ACTUAL BUILD DESIGN DECEMBER 2016

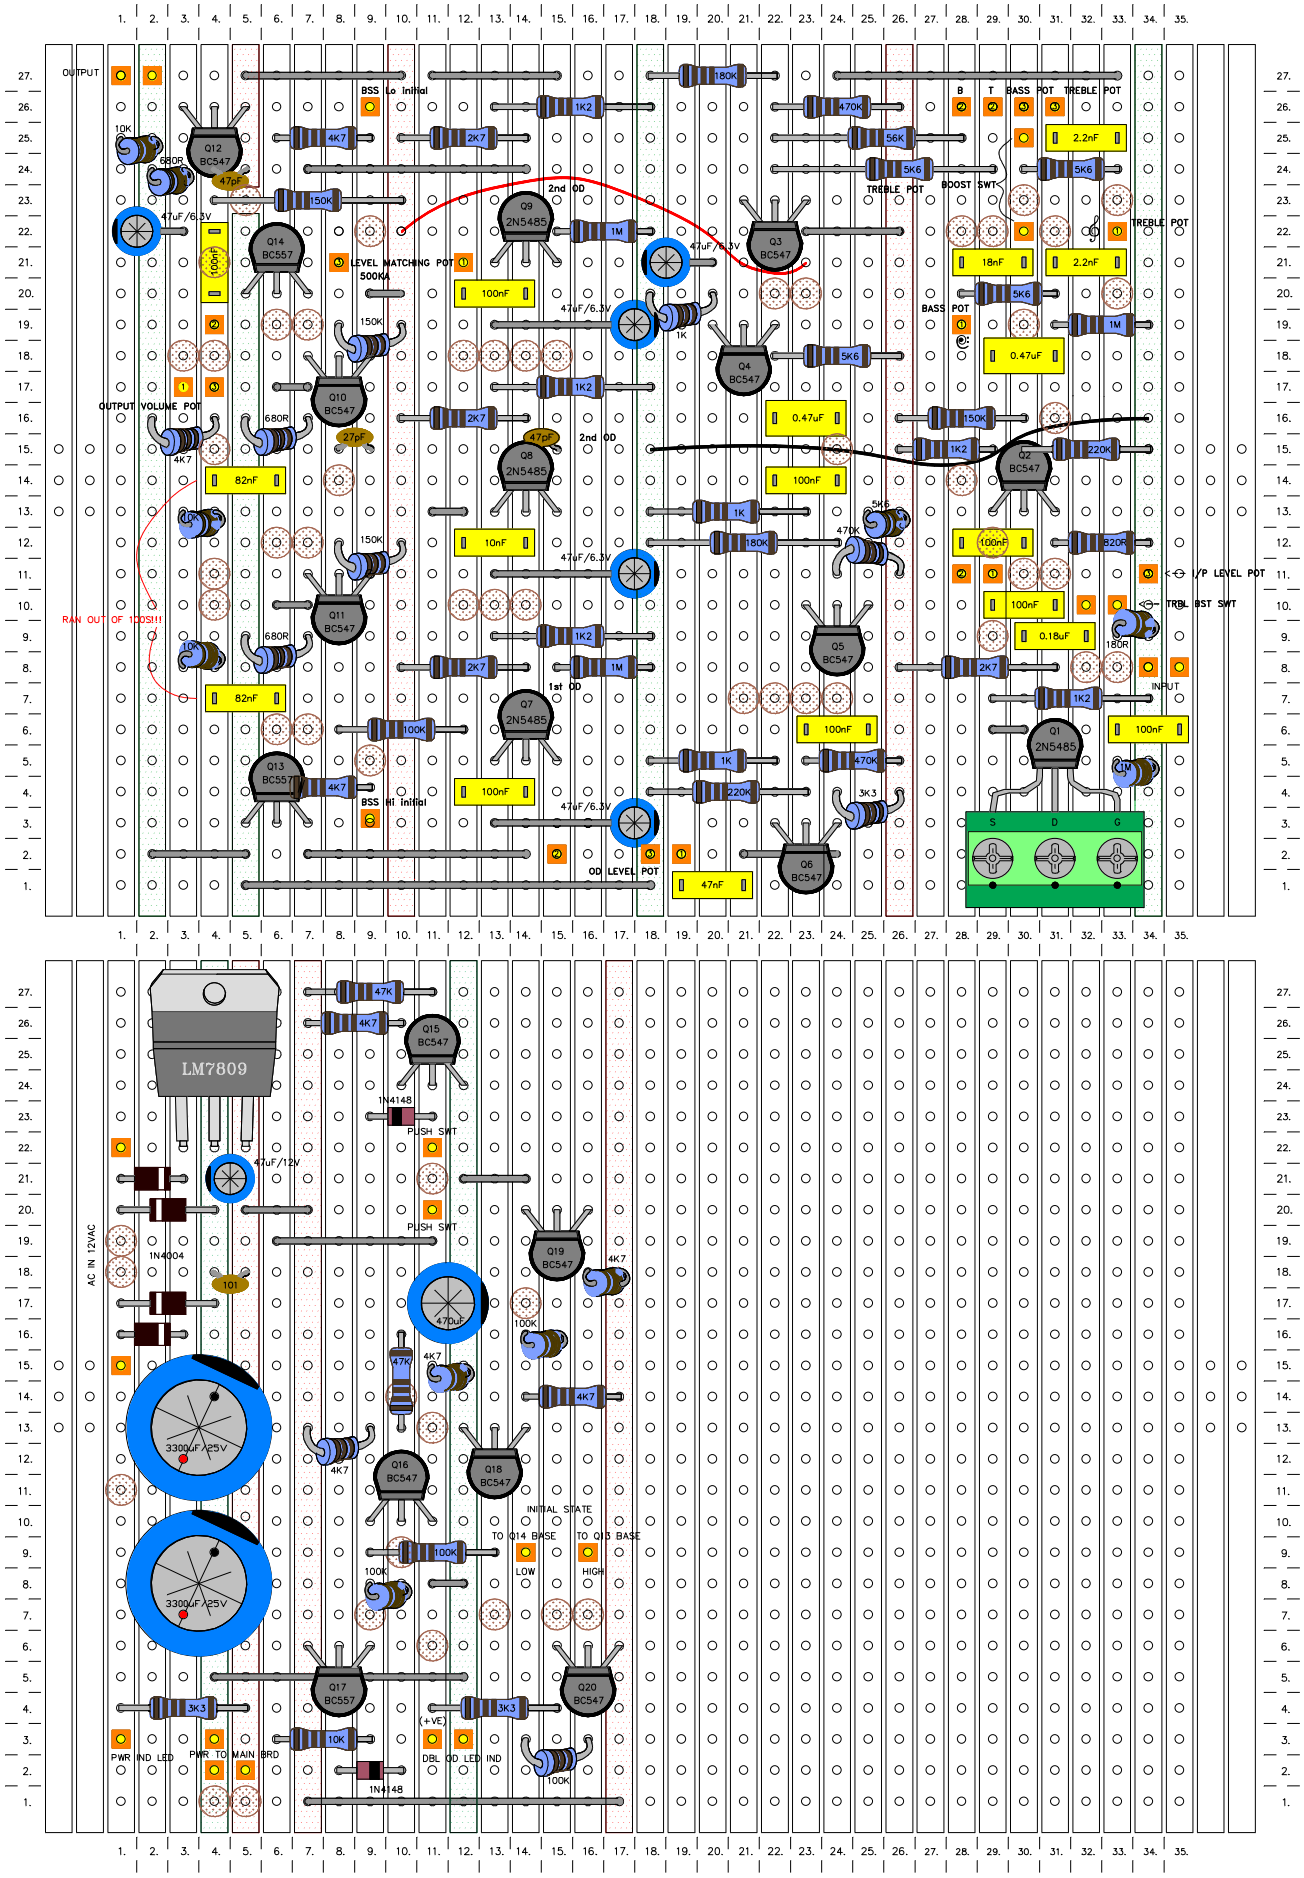
* Source resistors on 2N5485s changed from 680R to 1K2 October 2021
Treble boost circuit on I/P FET changed from 150nF/470R to 0.18uF/180R
